#### Airworthiness Directives; Eurocopter Deutschland GmbH Model EC 135 Helicopters

**ACTION:** Notice of proposed rulemaking (NPRM).

**SUMMARY:** This document proposes the superseding of an existing airworthiness directive (AD), applicable to Eurocopter Deutschland GmbH (ECD) Model EC-135 helicopters. The existing AD requires conducting a tail rotor drive shaft vibration survey (survey), installing a Fenestron Shaft Retrofit Kit, inspecting each tail rotor drive shaft bearing (bearing) attaching lock plate for bent-open tabs and broken or missing slippage marks, and visually inspecting each bearing support for cracks. This action would require conducting the survey and installing the Fenestron Shaft Retrofit Kit. This AD would also require installing double bearing supports and struts, revising the required compliance time for the repetitive inspections of the bearing attach hardware and supports, and removing the requirement to contact the FAA if a lock plate tab is bent open or if slippage marks are broken or missing. This proposal is prompted by continued reports of misaligned or cracked bearing supports and loose bearing attachment bolts. The actions specified by the propos

**Figure 1**

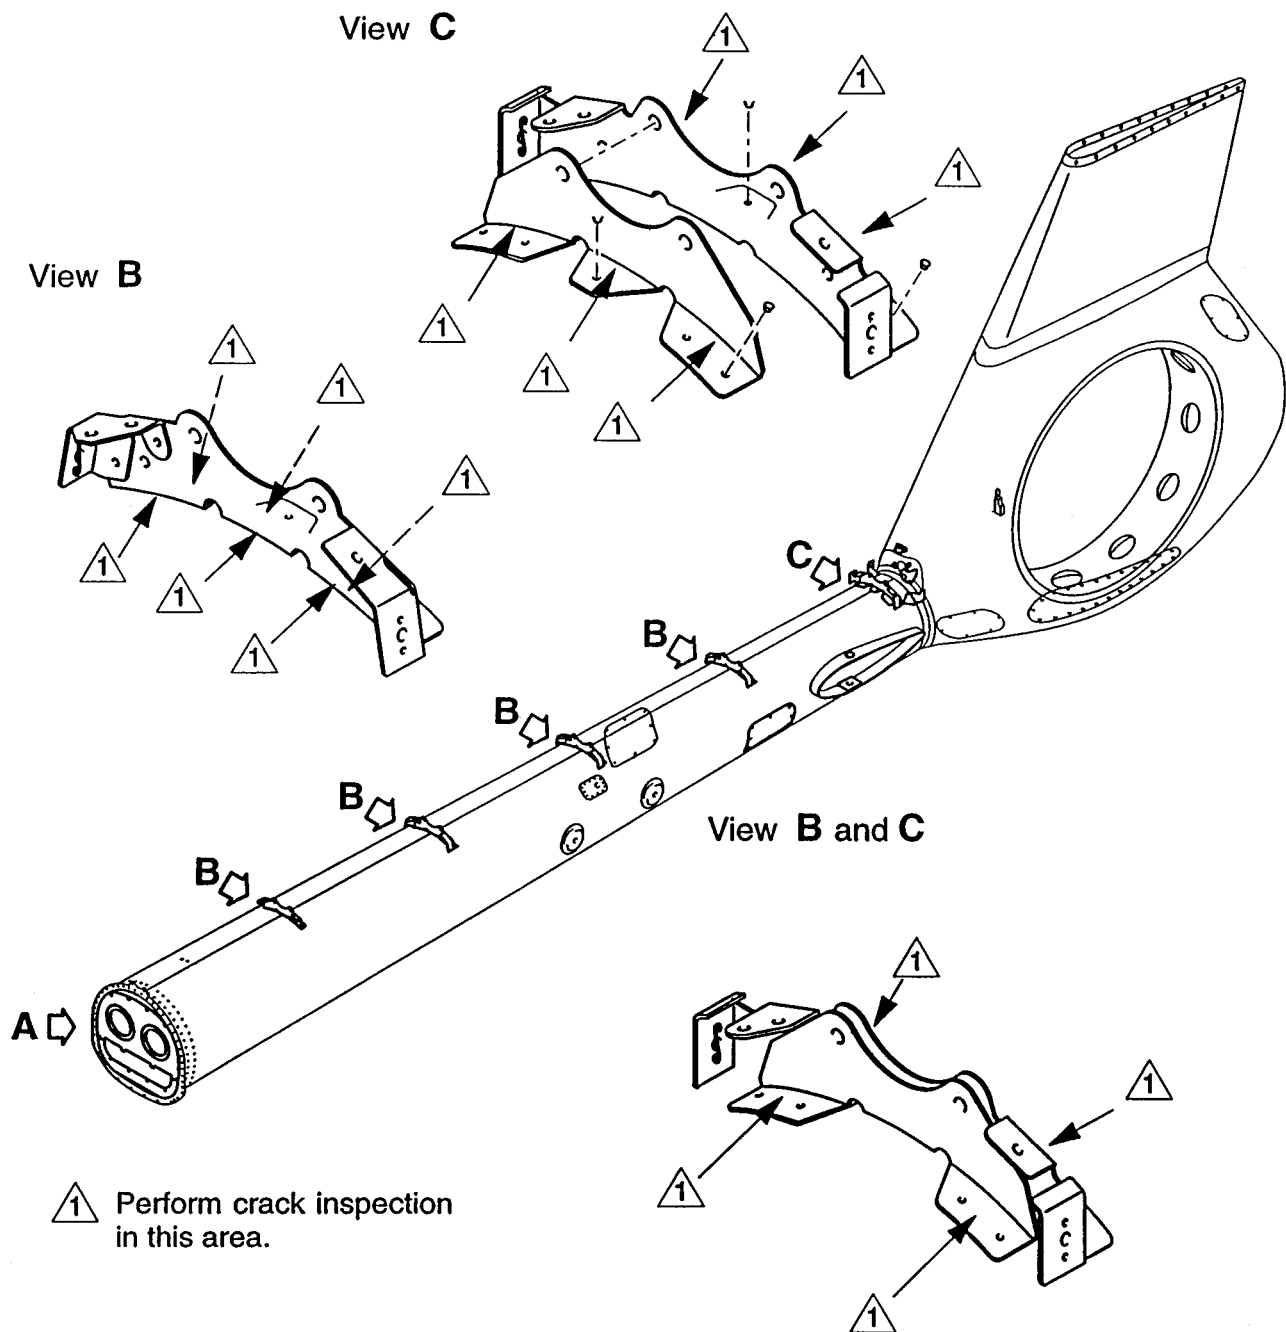
(1) Clean each tail rotor drive shaft bearing support. Using a 6-power or higher magnifying glass and a bright light, visually inspect the attach lugs of the bearing supports B and C (shown in Figure 1) for cracks, particularly in the area extending from the bend radius to the attaching screws and rivets connecting the bearing supports to the tail boom. Before further flight, replace each cracked bearing support with an airworthy bearing support.
